2.5 ORGANIZATIONS

Count and Mitigate Impacts of Climate Change in Draft EIR and General Plan Comments and Recommendations

To: Ventura County Board of Supervisors
From: Jan Dietrick and 204 Signatories

Revised Figure 4.12-1 Oil and Gas Well 2,500 foot Setback from Schools

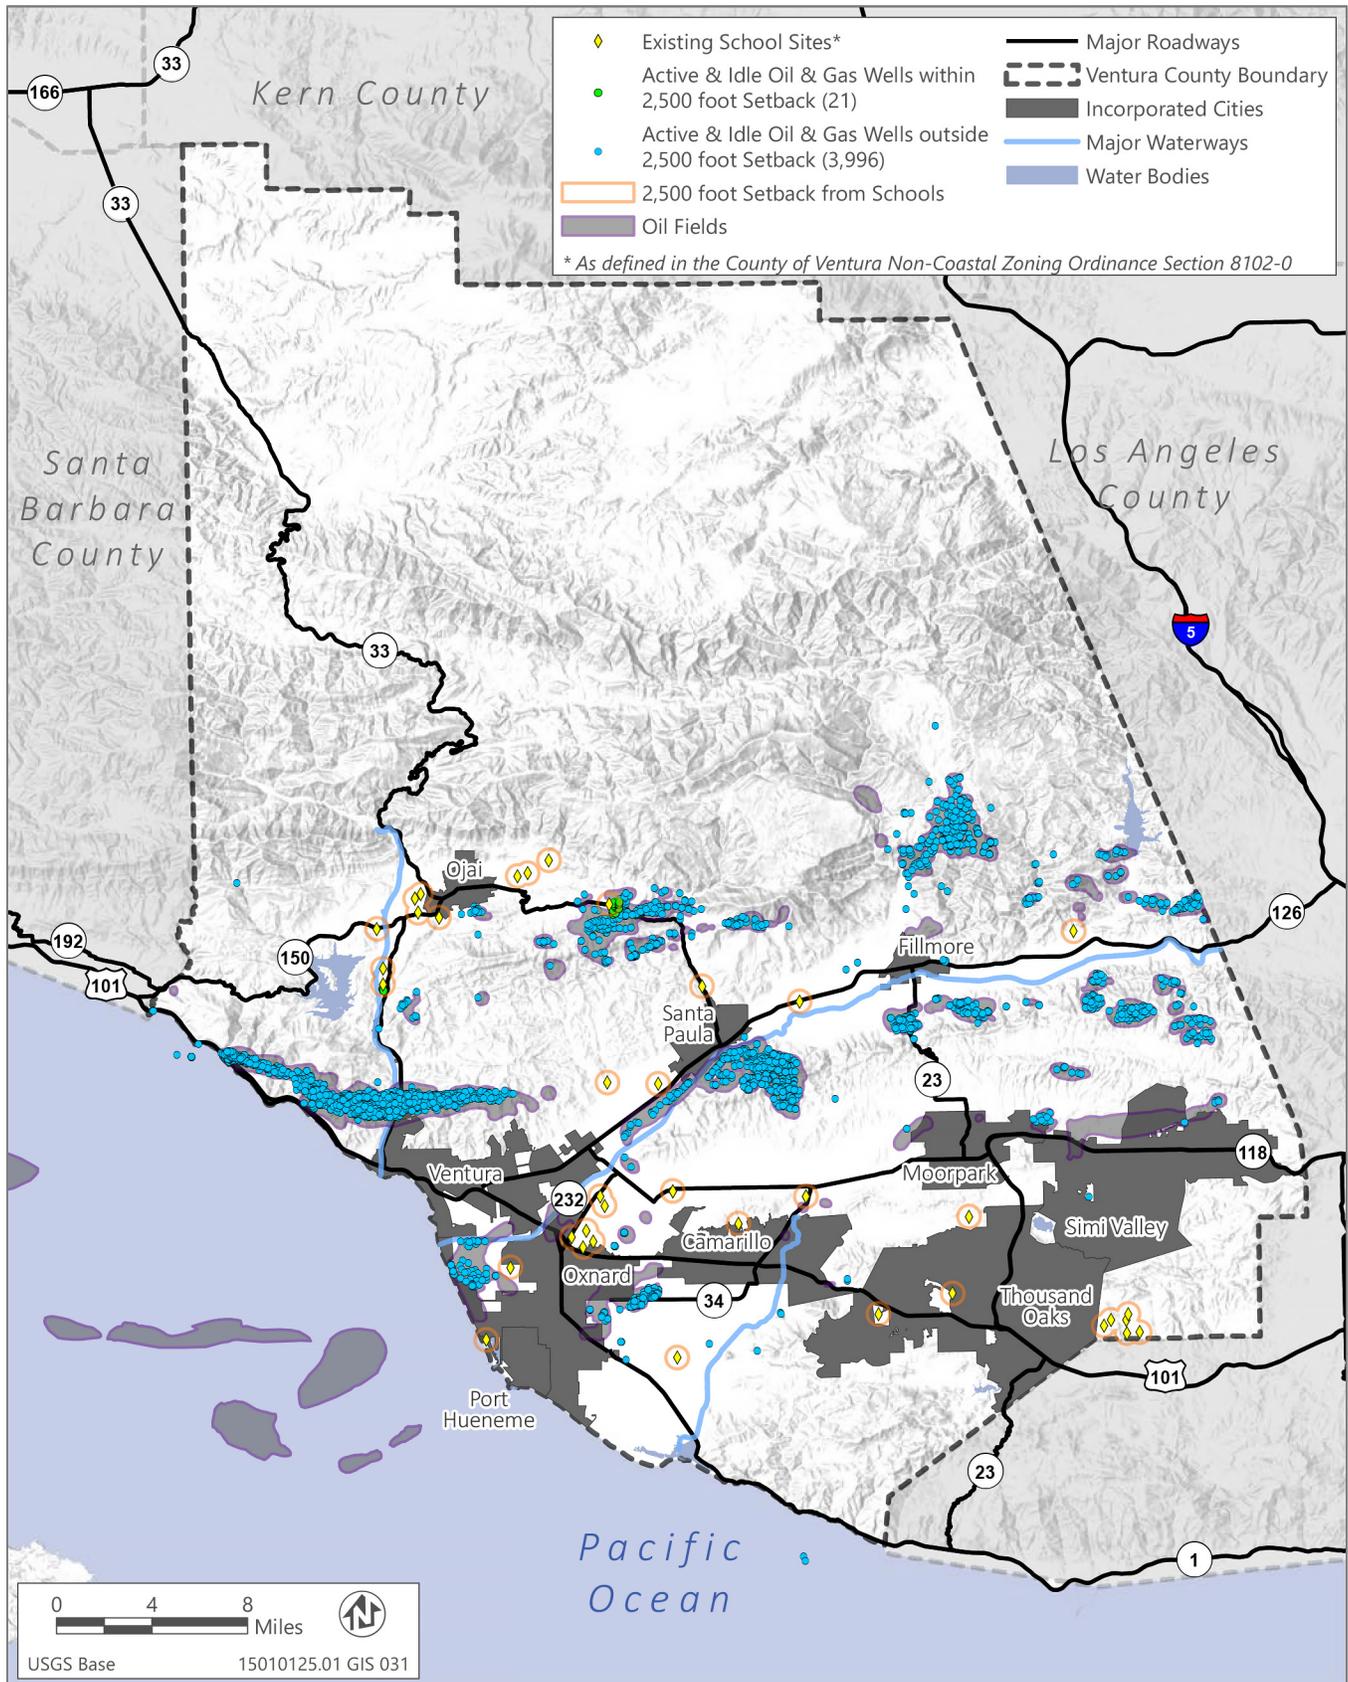
4.12 Mineral and Petroleum Resources	4.12.2 Environmental Impacts and Mitigation Measures Figure 4.12-1 & 4.12-2	4.12-15 4.12-16	The scale of the maps identified in Figure 4.12-1 and 4.12-2 make it difficult to see the scope of wells affected by the setback requirements. Multiple maps should be included in this section displaying a more accurate scale so that the maps are useful to the public to properly see	O15-23

the scale of impact. Additionally, a table should be provided identifying the number of wells affected by this policy.	
4.12 Mineral and Petroleum Resources	4.12.2 Environmental Impacts and Mitigation Measures Figure 4.12-1	4.12-15 4.12-18	Subparagraph titled “Significance after Mitigation” on page 4.12-18 states, “NCZO defines schools as educational facilities for pre-college levels of instruction; specifically limited to elementary, middle school and high schools offering full curricula as required by State Law.” Colleges, such as Thomas Aquinas College, do not meet this definition but are identified in the map provided in Figure 4.12-1. These Colleges should be removed from the analysis of the maps as they do not apply to this definition of a school.	O15-23 cont.

O15-23 Refer to Master Response MR-4, Section MR-4.H, “Buffers (Setback),” Section MR-4.E, “Applicability of Reference Studies for Oil and Gas Operations,” and Section MR-4.G, “Pipeline Requirements,” regarding the findings and conclusions related to setbacks, and the adequacy of the reports used to derive the findings and conclusions. Additionally, the commenter notes that Thomas Aquinas College, which does not meet the definition of a school pursuant to Policy COS 7.2, is incorrectly identified in the draft EIR Figure 4.12-1, Oil and Gas Well 2,500-ft Setback from Schools Map (page 4.12-5). Figure 4.12-1 includes the following notation in the legend “As defined in the County of Ventura Non-Coastal Zoning Ordinance Section 8102.” The draft EIR indicates that the Ventura County Non-Coastal Zoning Ordinance (Section 8102-0 defines schools as educational facilities for pre-college levels of instruction; specifically limited to elementary, middle school and high schools offering full curricula as required by State law. The Ventura County Coastal Zoning Ordinance does not include a definition for schools (page 4.12-18). The commenter is correct that Thomas Aquinas College was incorrectly depicted on Figure 4.12-1. Furthermore, the legend on Figure 4.12-1 did not include the full citation for the Section 8102-0 of the Non-Coastal Zoning Ordinance. Figure 4.12-1 has been revised in response to this comment, as shown below.

As a result of the figure revisions made in response to this comment, the last sentence of the second paragraph on page 4.12-14 in Section 4.12, “Mineral and Petroleum Resources,” is revised as follows:

As shown in Figures 4.12-1 and 4.12-2, there are currently 21 ~~23~~ active and idle oil wells within 2,500 feet of existing schools and 715 active and idle oil wells within 1,500 feet of existing dwelling units in the unincorporated county.

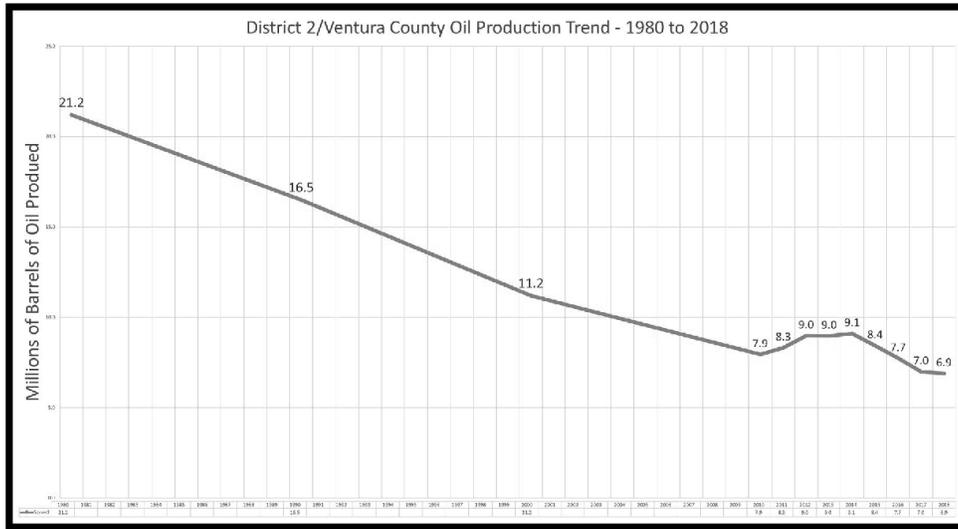
However, the “Oil and Gas Production Forecast” found in Appendix D – GHG Calculations inexplicably models increasing production through 2050, from 8.43 million barrels in 2015 to nearly 9.5 million barrels in 2050. Such a production forecast flies in the face of the historic Ventura County oil production data (see Figure 1 – Historic Ventura County Oil Production Trend, source: https://www.conservation.ca.gov/calgem/pubs_stats/annual_reports/Pages/annual_reports.aspx; also see Attachment 2 – Historic Ventura County Production Data 1980 to Present).

The actual data indicate a steady decline in production looking back 35 years from 2015, which mirrors the forward-looking timeline in the Oil and Gas Production Forecast. This long-term historic trend is recognized in the GPU Background Report section on Petroleum Reserves (page 8-74):
